AMENDMENTS TO THE DRAWINGS

Please replace drawing sheets 2, 3, 5, 6, and 7 with the newly-submitted figures attached herewith on separate sheets labeled “Replacement Sheet.” A marked-up copy of these sheets is also included for further explanation, labeled “Annotated Sheet.” The following are the changes and/or corrections made to the drawings:

REMARKS

This is a full and timely response to the outstanding non-final Office Action mailed November 30, 2004 (Paper No. 11112004). Upon entry of this response, claims 1-15 are pending in the application. Applicants respectfully request that the amendments being filed herewith be entered and request that there be reconsideration of all pending claims.

Fig. 3

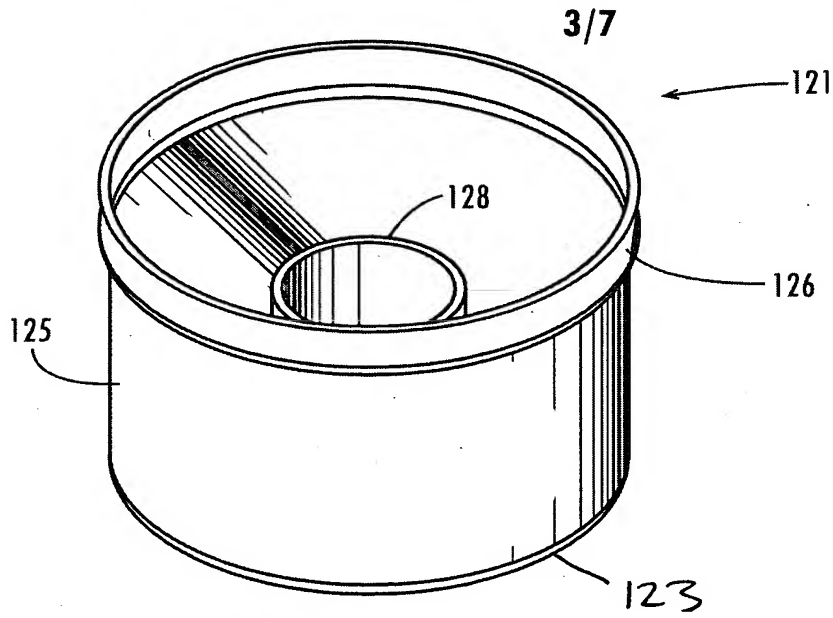
Fig. 3:

- 1) added reference 123 for base

Fig. 7

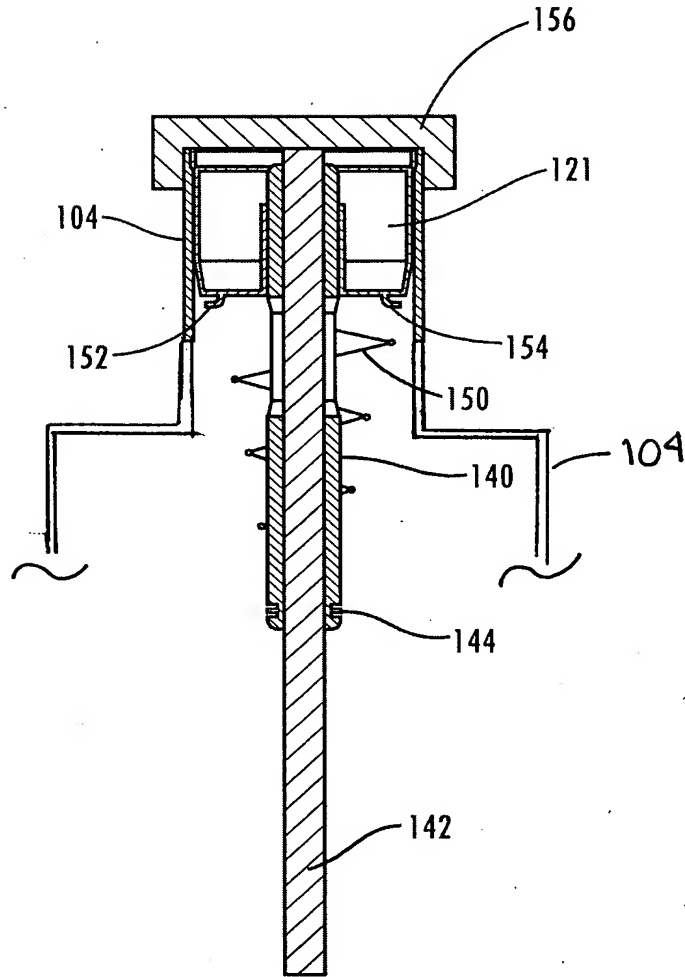
Fig. 7:

- 1) added reference for reservoir 104
- 2) modified structure of reservoir 104

Fig. 8

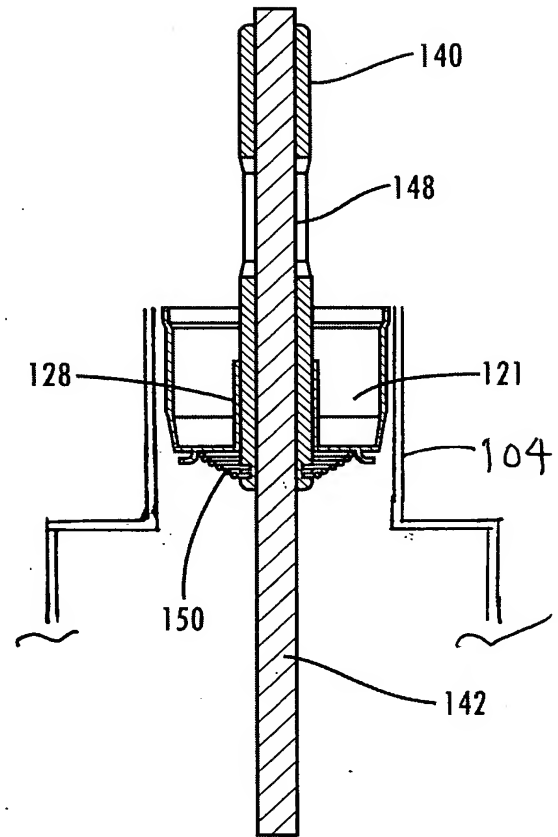
Fig. 8:

- 3) added reference for reservoir 104
- 1) modified structure of reservoir 104

Fig. 9

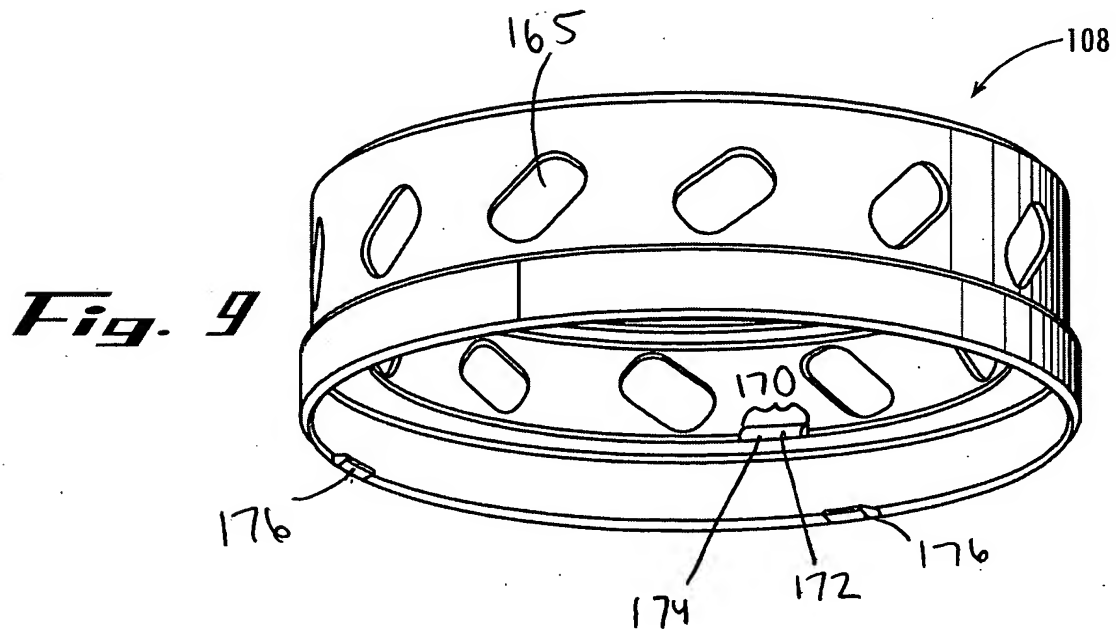
Fig. 9:

- 1) added reference 165 for vent hole
- 2) added reference 170 for mechanical stop
- 3) added reference 172 for pin
- 4) added reference 174 for slot
- 5) added reference 176 for tab

The drawings have been objected to under 37 CFR 1.84(p)(5). Specifically, the Office Action states that the drawings “do not include the following reference sign(s) mentioned in the description: in Figures 9 and 10: vent holes 165, mechanical stop 170, pin 172, and slot 174; and in Figure 9: base 161, tabs 176, and exterior threads 178.”

A proposed drawing correction to Figure 9 is submitted with this Response. The correction shows newly added reference signs for base 161, holes 165, stop 170, pin 172, slot 174, and tabs 176. A proposed drawing correction to Figure 10 is also submitted with this response. The correction shows newly added reference signs for holes 165. Applicants respectfully submit these corrections overcomes the drawing objection with regard to reference numerals 161, 165, 170, 172, 174, and 176 in Figures 9 and 10.

Applicants respectfully traverse the drawing rejection as it relates to exterior threads 178 and Figure 9. The reference to threads 178 in the specification refers to Figure 11, not Figure 9: “Referring briefly to FIG. 11, these tabs are sized and arranged to engage exterior threads 178 formed at an upper edge of lamp base 102.” (Specification, p. 8, lines 9-10.) Applicants respectfully request that the drawing objection with regard to Figure 9 and reference numeral 178 be withdrawn.

Fig. 10

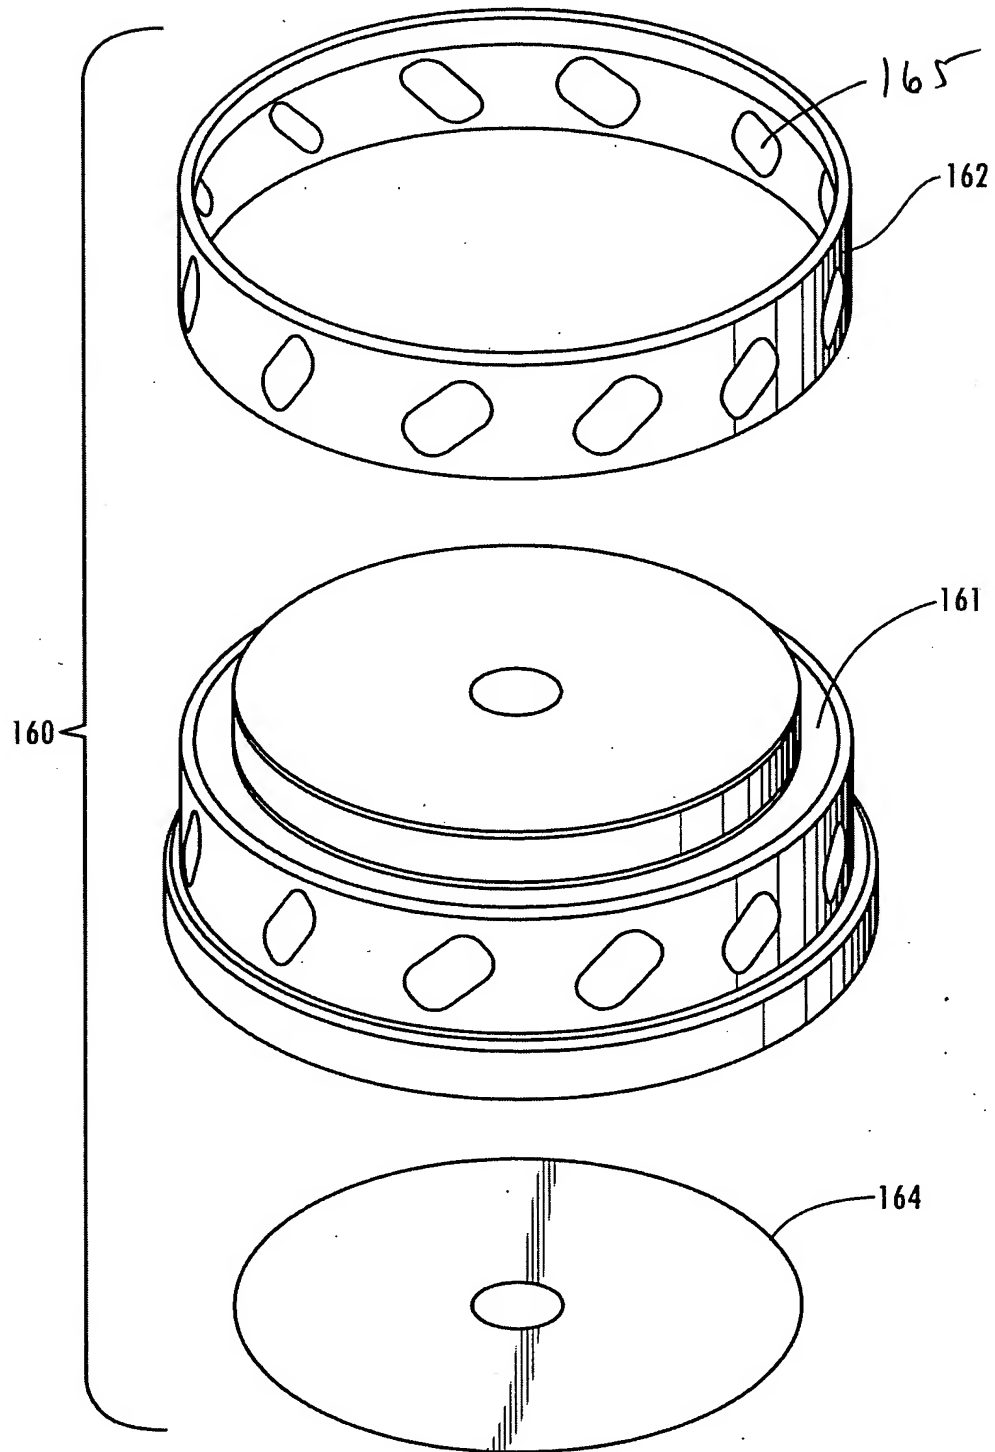
Fig. 10:

- 1) added reference 165 for vent hole

Finally, Applicants have amended the description of stop 170, pin 172 and slot 174 (Specification, p. 7, line 19 to p. 8, line 3) to refer only to Figure 9, rather than to Figures 9 and 10. Applicants respectfully submit that this specification amendment overcomes the drawing objection with regard to Figure 10 and reference numerals 170, 172 and 174.

Fig. 11

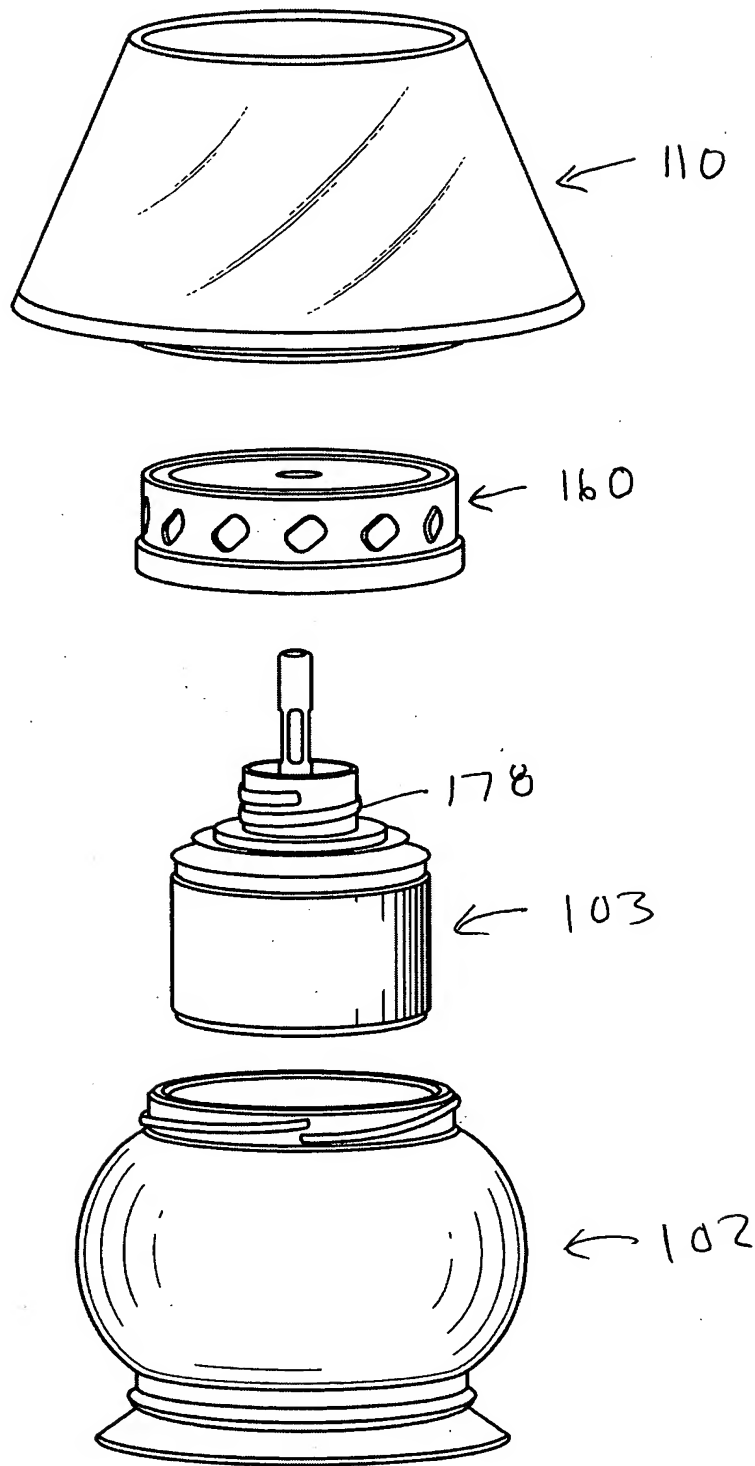
Fig. 11:

- 1) added reference 102 for base
- 2) added reference 103 for fuel-supply module
- 3) added reference 110 for shade
- 4) added reference 160 for adjustable collar assembly
- 5) added reference 178 for external threads
